AMERICAN SUZUKI MOTOR CORPORATION

12V-231
(5 Pages)

May 18, 2012

Location of Side Stand Interlock Switch

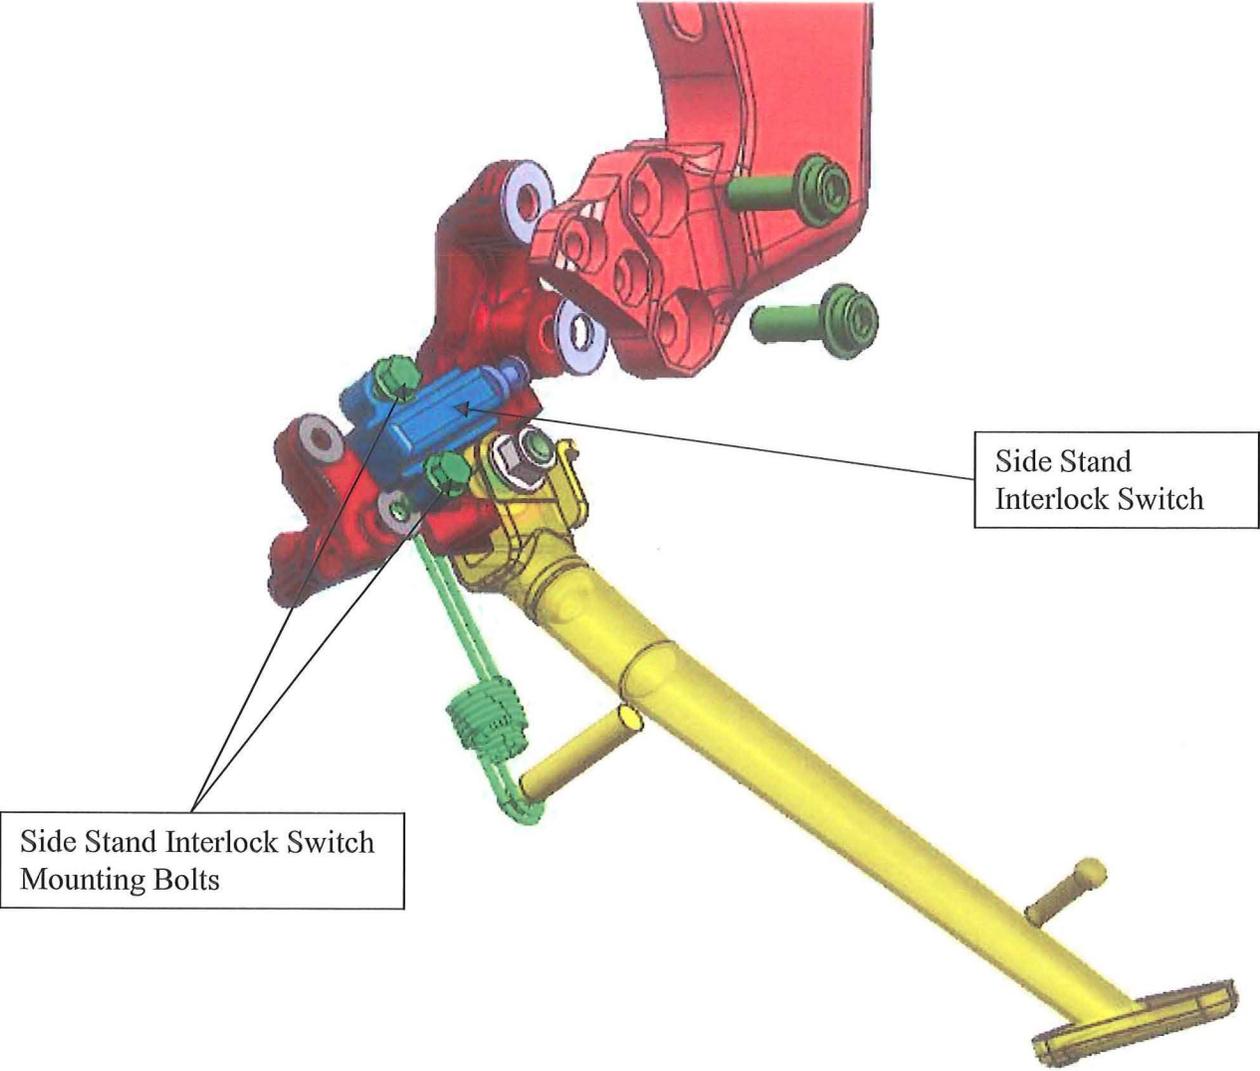
The defect involves the side stand interlock switch, which is provided to cut off the ignition circuit when the side stand is down and the transmission is in any gear other than neutral. Attached is an illustration showing the location of the side stand interlock switch.

The flange-head bolts used to mount the side stand interlock switch on the side stand bracket have a small-diameter flange that bears against the surface of the switch body, which is made of a zinc alloy. Because of the small diameter of the bolt flanges and small bearing surface of the bracket, compression buckling of the bolt side and bracket side of the switch body can occur and the bolts may loosen. Vibration can cause the bolts to turn and they can eventually come out. If a bolt comes out while riding, the body of the interlock switch can rotate, allowing the switch plunger to come out, cutting off the ignition circuit. This will cause the engine to stop running, increasing the risk of a crash.

Suzuki dealers will replace side stand interlock switch flange-head attachment bolts with bolts which have a larger-diameter flange and which are pre-coated with an adhesive material. Also, washers will be added to the interlock switch attachment seats and to the side stand bracket attachment seats.
